### Application for Project Review Garden City, Utah

Project Name: Cottonwood Sub. Current Zone: R1 Proposed Zone: R1

DATE: March 16, 2016  
 TO: Garden City Planning Commission  
 CC: Riley Argyle, Bob Petersen  
 FROM: Zan Murray S.E.  
 SUBJECT: Conttonwood Subdivision Preliminary Plat Review

A second submittal of the Cottonwood Subdivision dated January 2016 has been submitted for review. Below are my comments from the review.

EXISTING CONDITIONS

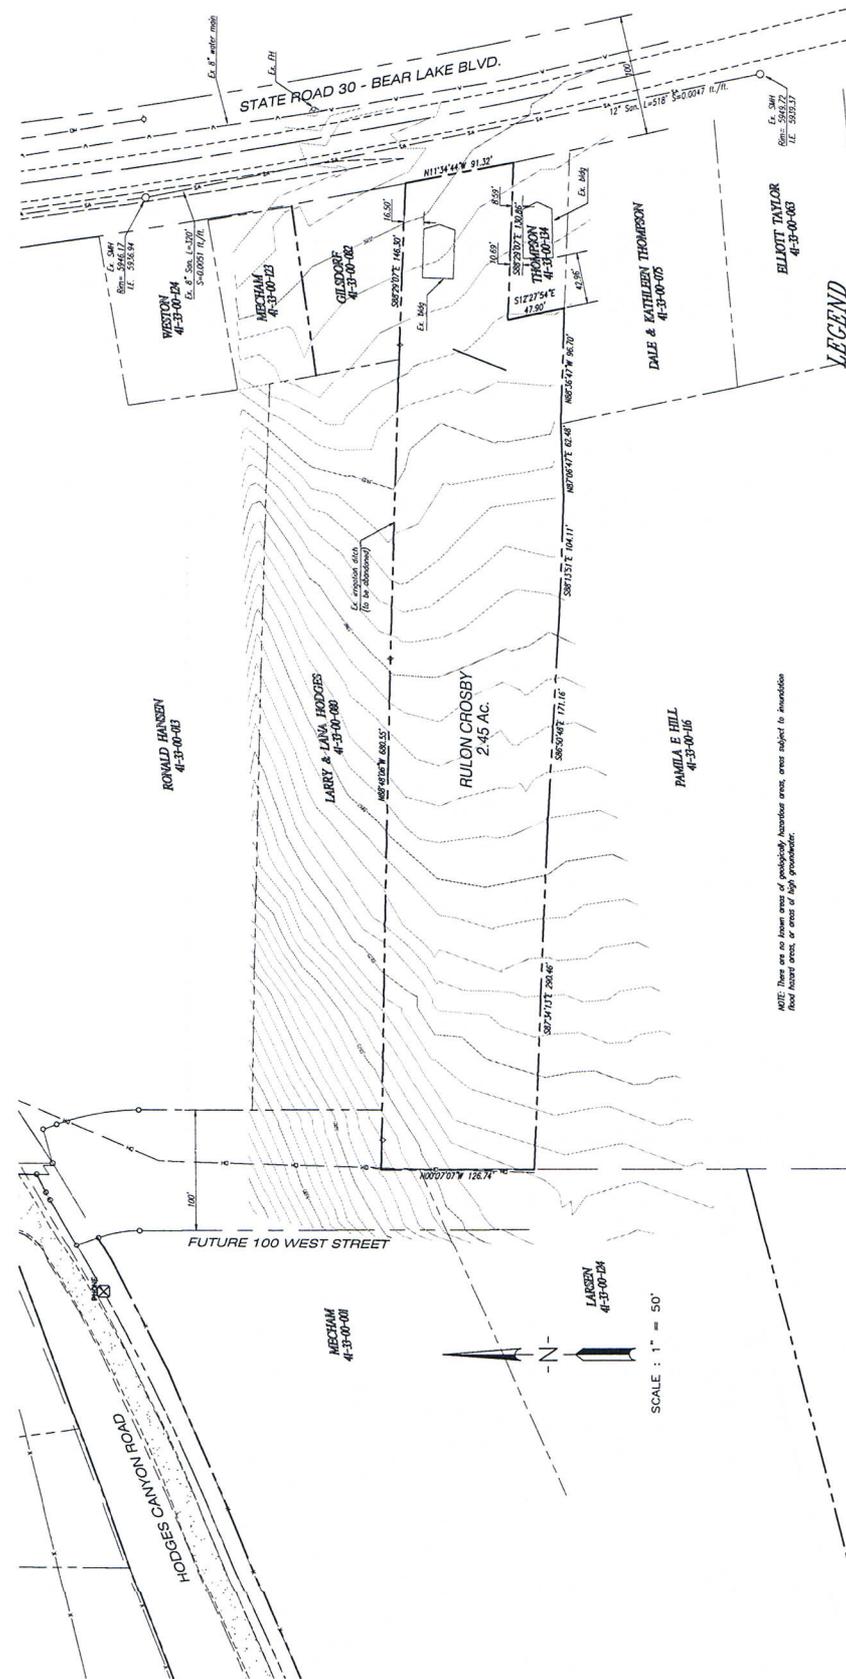
11. The location, width and names of all existing streets within two hundred (200) feet of the subdivision and of all prior platted streets or other public ways, and utility right-of-ways, parks, and other public open spaces, permanent buildings and structures, houses or permanent easements and section and corporation lines, within adjacent to the tract. – **The street detail shows a 10' PUE on the north of the subdivision boundary. A PUE should be provided on the north side of the property. This will account for the power poles. Does the Sewer Easement extend along the entire length of the property? It is not clear on the plan.**

13. Existing sewers, water mains, culverts or other underground facilities within the tract and to a distance of at least one hundred (100) feet beyond the tract boundaries, indicating pipe sizes, grades, manholes and exact location. – **Existing sewer along SR-30 is not shown sufficiently with manhole elevations. The waterline size on SR-30 is ashown.**

14. The location, size, and type of sanitary and storm sewers, water mains, culverts and other surface or subsurface structures existing within or immediately adjacent to the proposed sanitary or storm sewers (a minimum distance of one hundred (100) feet), water mains, and storage facilities, street improvements, street lighting, curbs, and gutters, and all proposed utilities (may be shown only on the engineering plans). – **Existing utility line sizes are not**

shown on the plans. Sewer does not extend past the driveway to the next manhole.  
Elevations are not shown on the plans.

15. Existing ditches, canals, natural drainage channels and open waterways, and proposed realignments. – **Not provided. There are likely irrigation ditches along the property lines.**

PLAN AND PROFILE

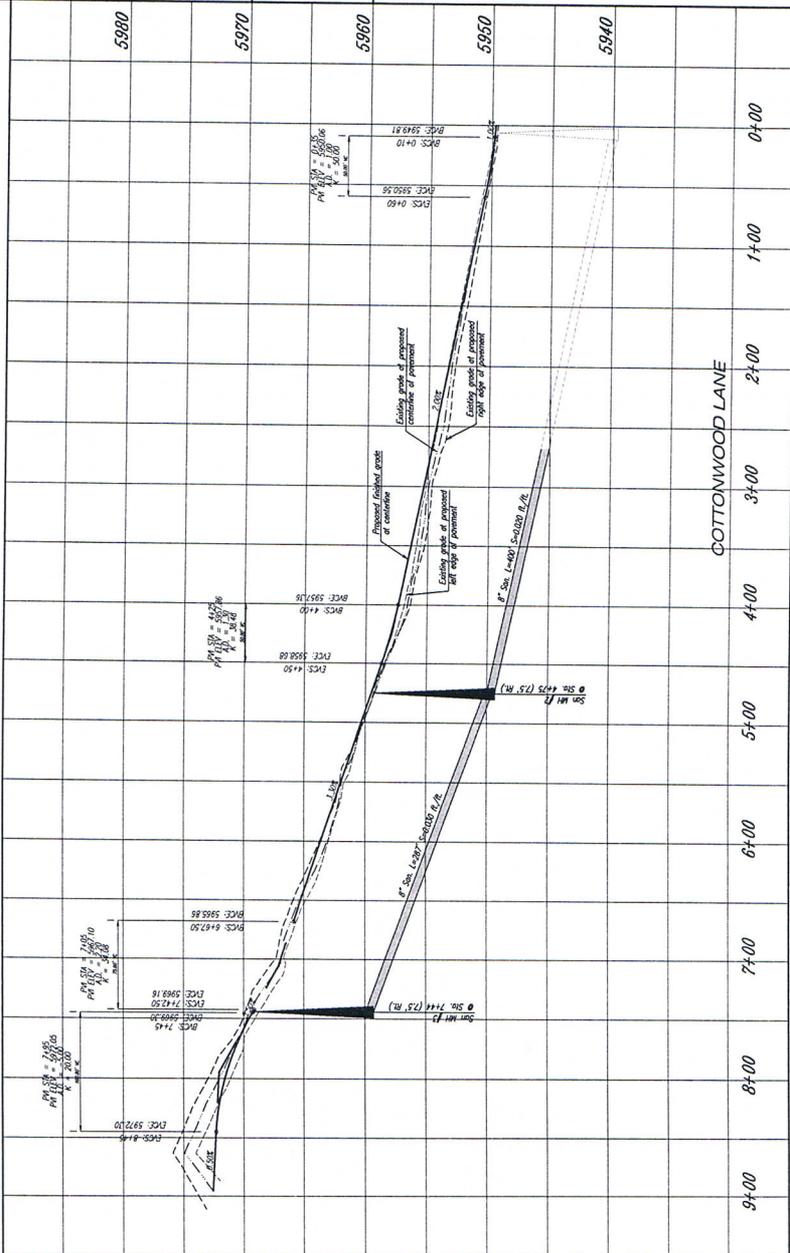
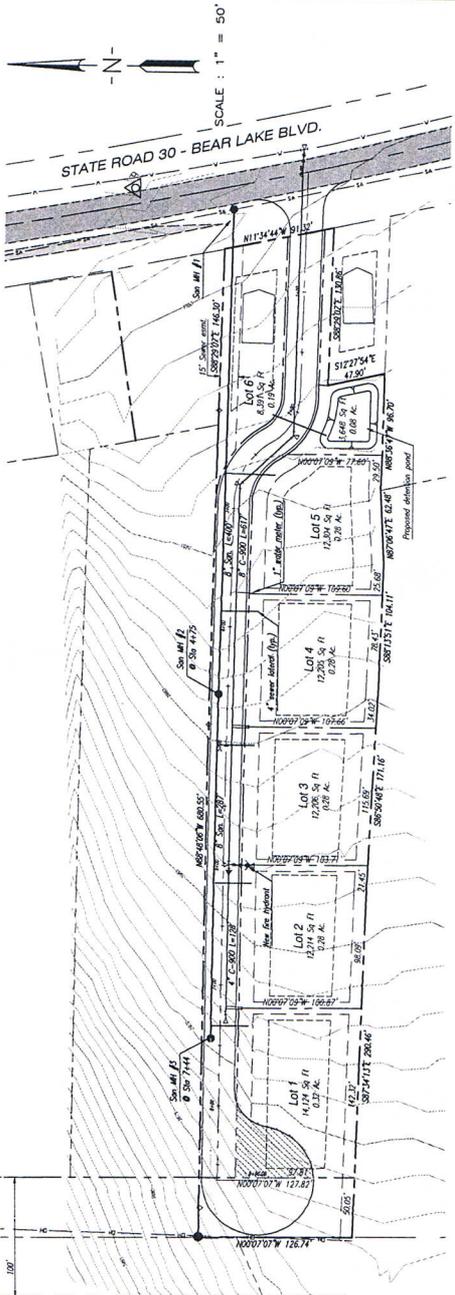
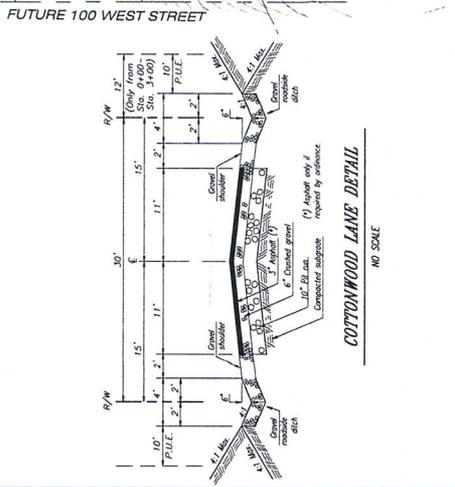
The street cross section overlaps onto the property to the north. An easement will be required in order to construct the swale as indicated on the cross section.

Elevations on the drainage pipe to the pond should be shown in the final construction drawings.

2. A minimum of two (2) entrances/exits required for each subdivision. All roadways shall have recorded easements. (Roadways shall be designed to incorporate the overall roadway plan for Garden City) – **100 West is a future access. This must be decided by the Planning Commission. A 96' diameter turnaround is required on the end of the private road. It should be dimensioned on the plan.**

6. Building setback lines -including showing dimensions where required by the Planning Commission. – **Setback lines are not labeled in the Legend (it appears as a concrete curb line).**

8. The boundaries of record of the tract, area of the tract, the proposed location, approximate grade, right-of-way width and pavement width of streets and alleys, locations of sidewalks; the proposed location and width of easements and setback lines, proposed lot lines, the radii of all curves, lot size and approximate lot dimensions. – **Show ROW and P.U.E. dimensions lines on the plan view.**

herewith. **The plat says that there will be sufficient capacity in the pond. This is yet to be determined. It will be required on the final construction drawings. The ordinance states that private roads must meet the design standards of the City. 11E-514.A states minimum street widths are 30 feet. According to paragraph X, Private Streets must be recommended by the Commission and approved by the Council. They must also meet all of the street standards. The definition of Private Street in 11A-200 Paragraph A.151 states that the street must meet fire code, but is not acceptable for dedication to the City. So can it be narrower than 30 feet if it is never dedicated.**
